Re: Revised Centralized E&P Waste Management Facility Form 28 Application
Facility ID #426582
Encana Oil and Gas (USA) Inc. NPR Solidification Facility

Rule Engineering, LLC is submitting the Colorado Oil and Gas Conservation Commission (COGCC) Revised Form 28 Application on behalf of Encana Oil and Gas (USA), Inc. (Encana) for the proposed North Parachute Ranch (NPR) Solidification Facility (NSF). The Form 28 was revised based on your review provided in a letter dated March 12, 2012. The revisions to the Form 28 Application and response to your review comments are noted below.

SUPPLEMENTAL MAP

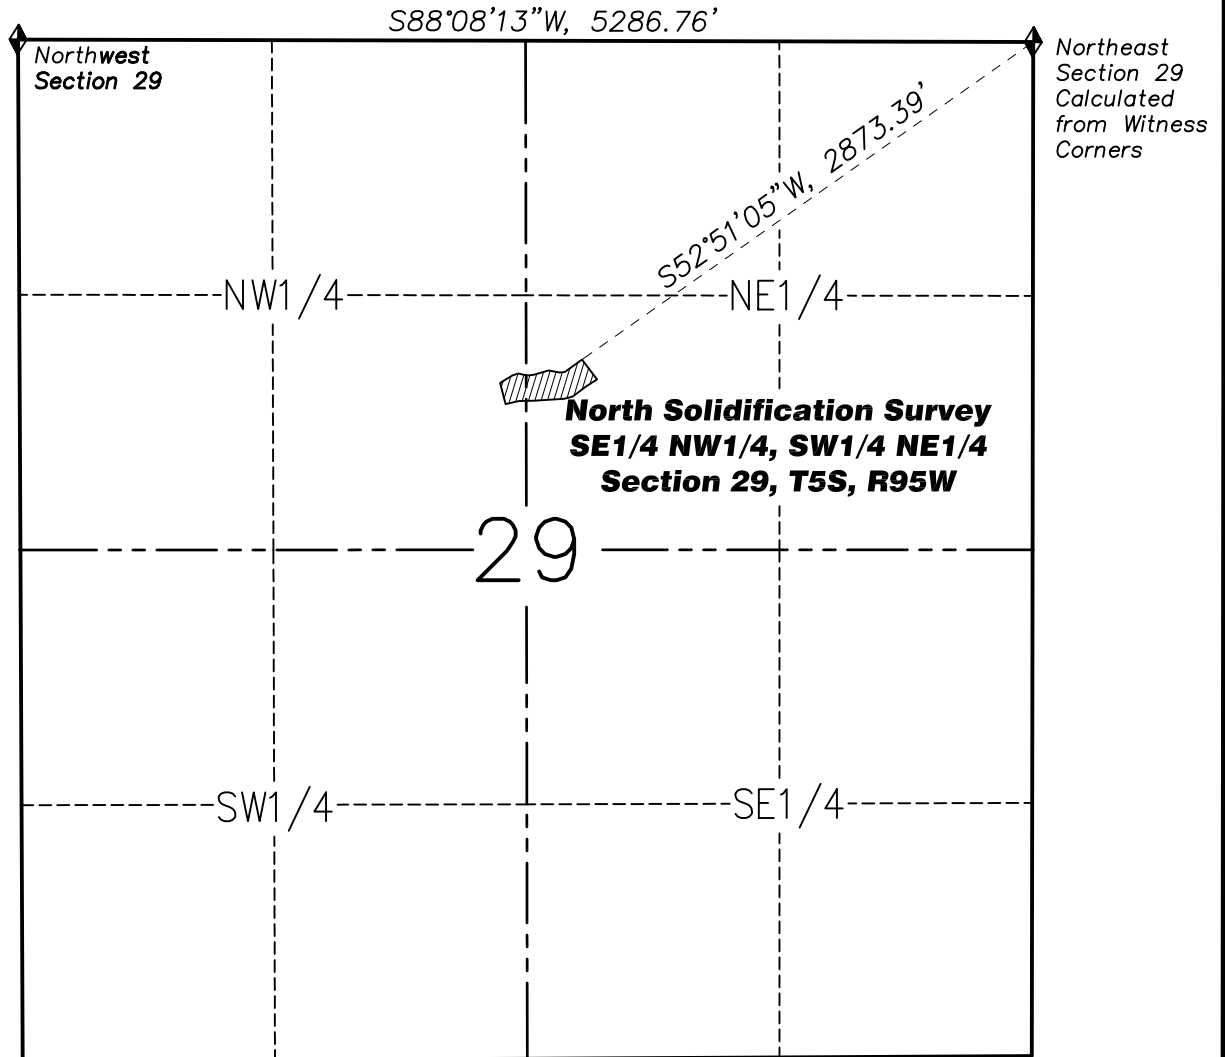
Form 28 Supplement, Rule 908.b(5)B

The Survey Plan provided in Attachment A references section corners. A Supplement Map is included in Attachment A to show the surveyed location of the section corners in relation to the NSF.

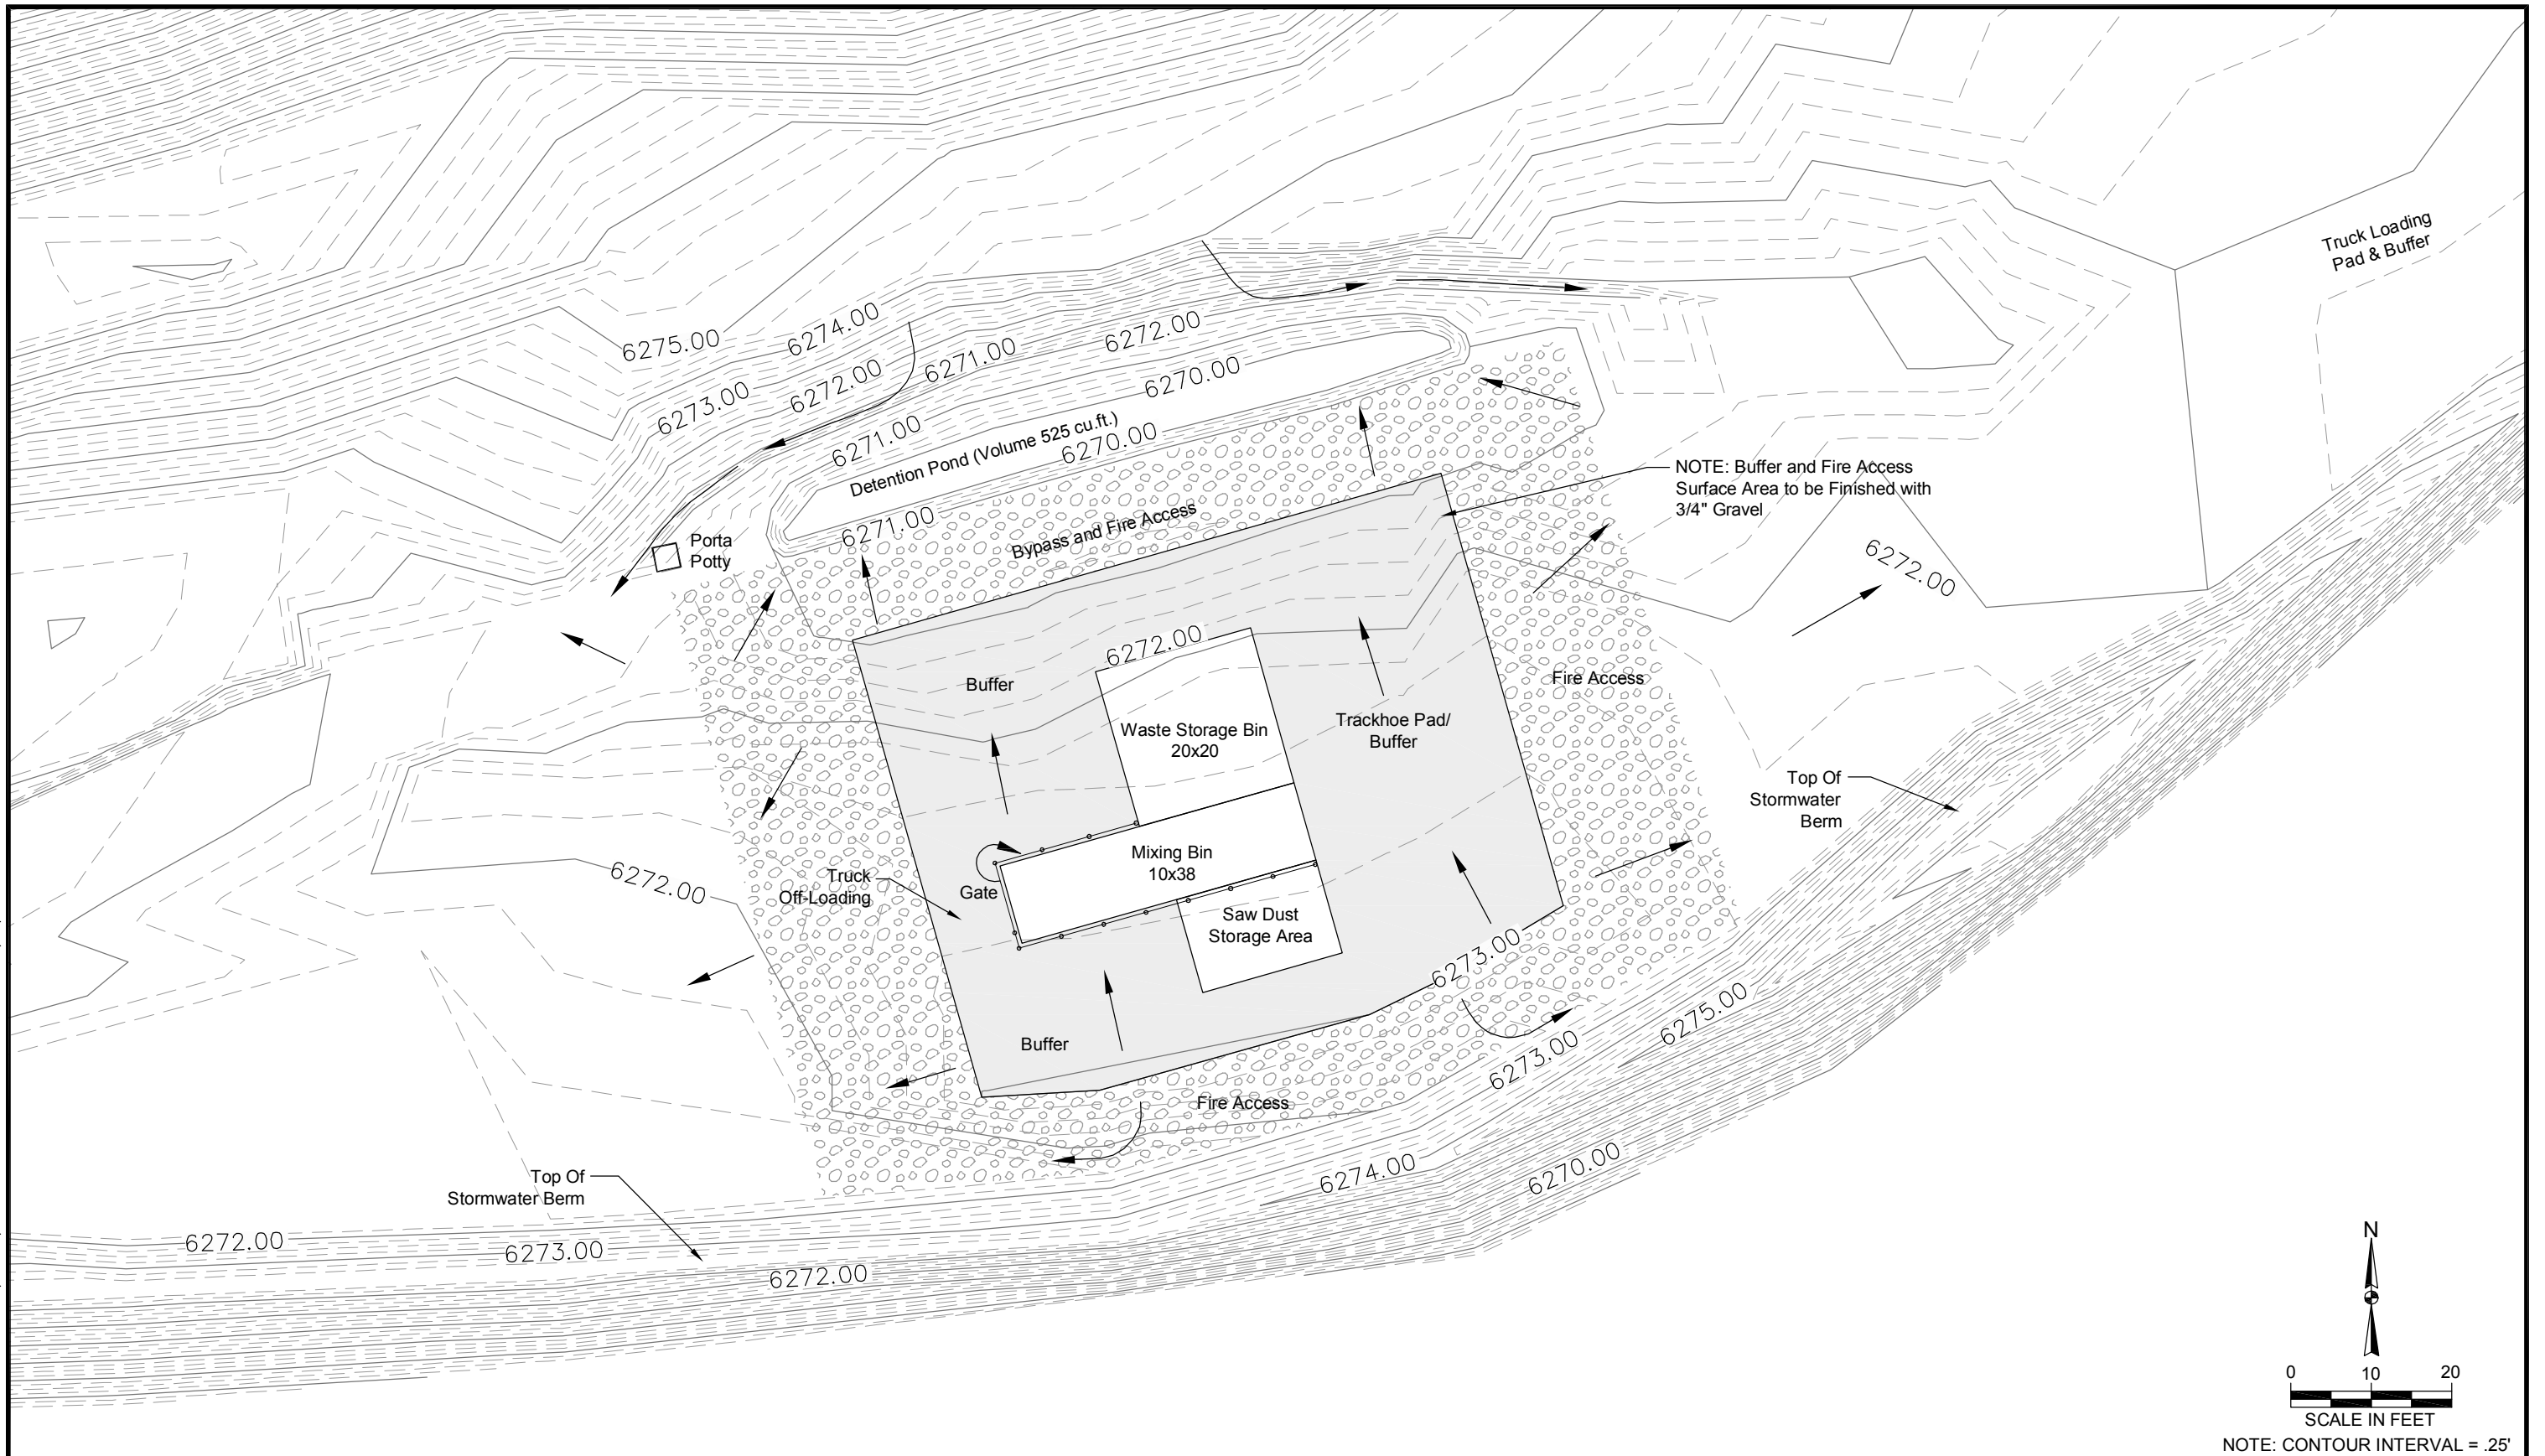
Form 28 Supplement, Rule 908.b(5)D

The surfacing material for the Buffer Area and Fire Access will be 3/4-inch gravel placed a minimum of 2-inches thick. A note has been added to Figure C1 on the Engineering Drawings.

The surface material in the Buffer Area and Fire Access roads will consist of 3/4-inch gravel placed to a minimum of 2-inches thick. A note has been added to Figure C1 regarding the surface material, this material will provide tracking control for equipment and trucks and maintenance of the tracking control will be included in the Operations Plan. The hydrovac trucks that deliver waste to the NSF Mixing Bin are equipped with water and can be washed before leaving the off-loading area at the Mixing Bin if deemed necessary. A detail of the sawdust storage area had been included in Figure C3. A gate to control access to the mixing bin has been included on Figure C1 and C2. Also Figure C2 has been modified to show the placement of the mixing bin in relation to the ground surface.
